# UNITED STATES PATENT AND TRADEMARK OFFICE

| APPLICATION NO.   | FILING DATE | FIRST NAMED INVENTOR | ATTORNEY DOCKET NO.            | CONFIRMATION NO. |
|---|-------------|----------------------|--------------------------------|------------------|
| 10/828,312  | 04/21/2004  | Cheng-Yung Chen      | CHEN3660/EM                    | 4222             |

## Office Action Summary

## DETAILED ACTION

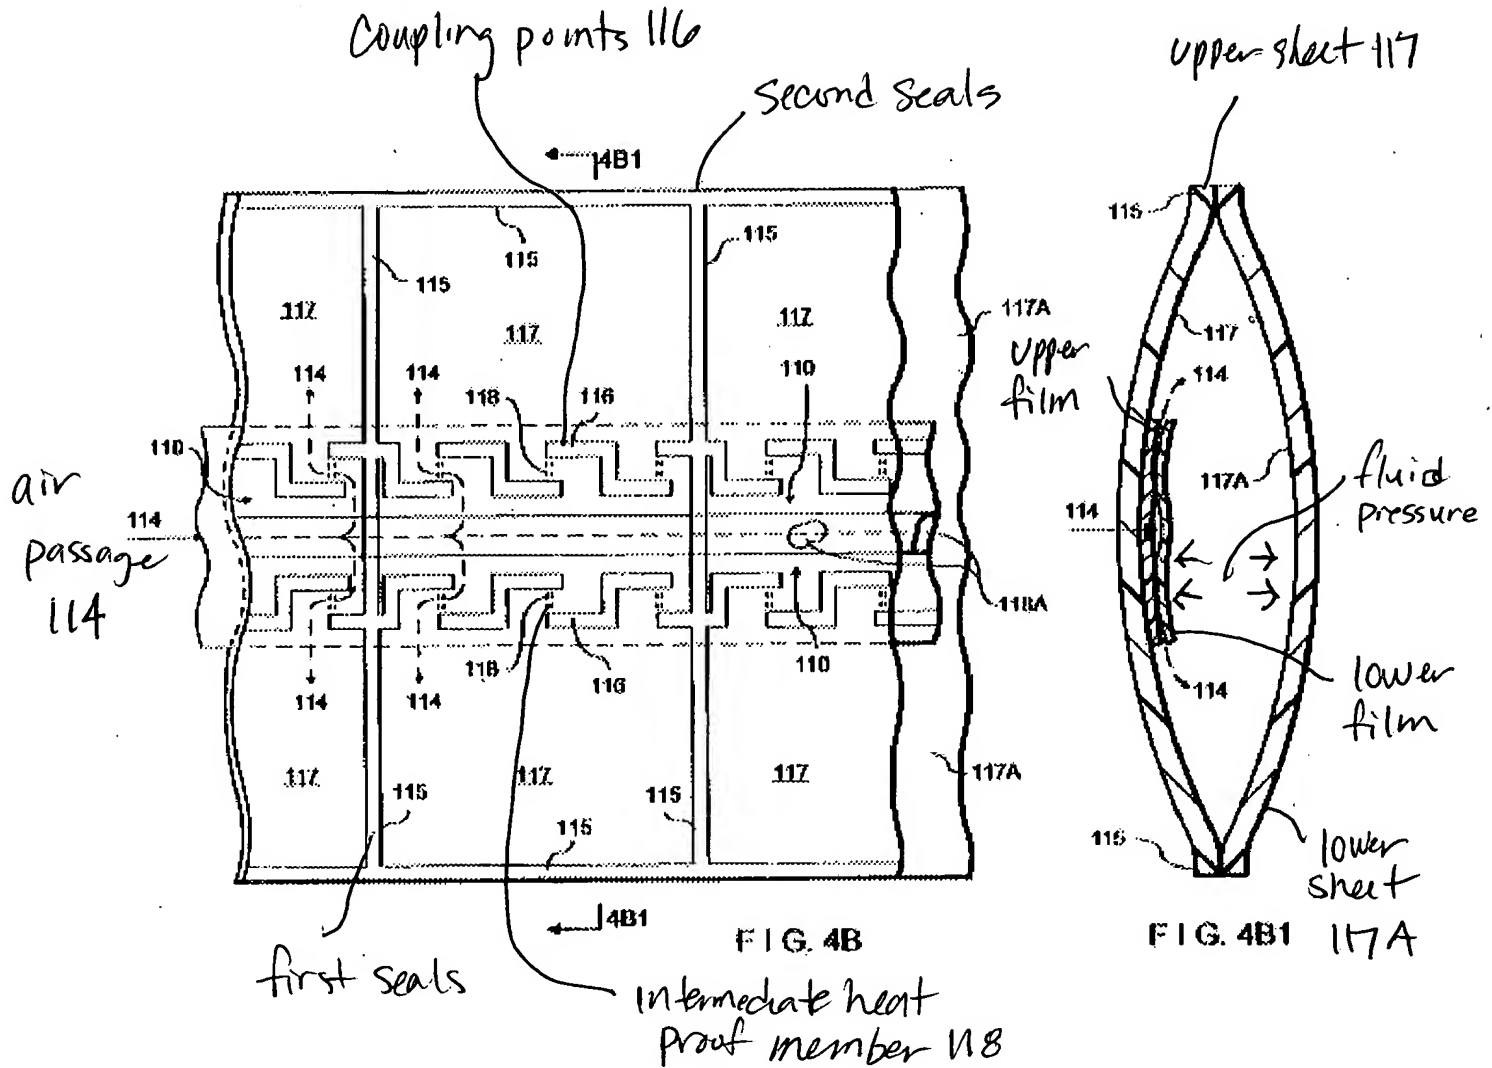
Re claim 14, Pharo discloses in Figs. 4B and 4B1 air packing bag, comprising an upper sheet 117, a lower sheet 117A an upper film and a lower film (both un-numbered in Fig. 4B1, see the reproduced figure below for the identification of these two elements) disposed within an air passage 114, an intermediate heat proof member 118, a plurality of bladders defined between the upper sheet and lower sheet defined by plurality of first seals (the intermediate seals 115) and second seals (those seals disposed at the lateral ends of the air packing bag which are not shown in the drawing 4B due to the drawing being a segment of the total device, and those seals 115 formed at the top and bottom of the device). The first seals are spaced apart. The air passage 114 is formed along the end of the bladders and communicates with an interior of each of the bladder and includes an open end which is best shown in the other drawing figures.

Re the new claim limitations, which appear to present the limitation of cancelled claim 16 almost verbatim, note coupling points 116 that secure the upper and lower films to the upper sheet 117. Internal air pressure would act to push the inner and outer films toward the sheet to which they are attached (see Figs. reproduced below).
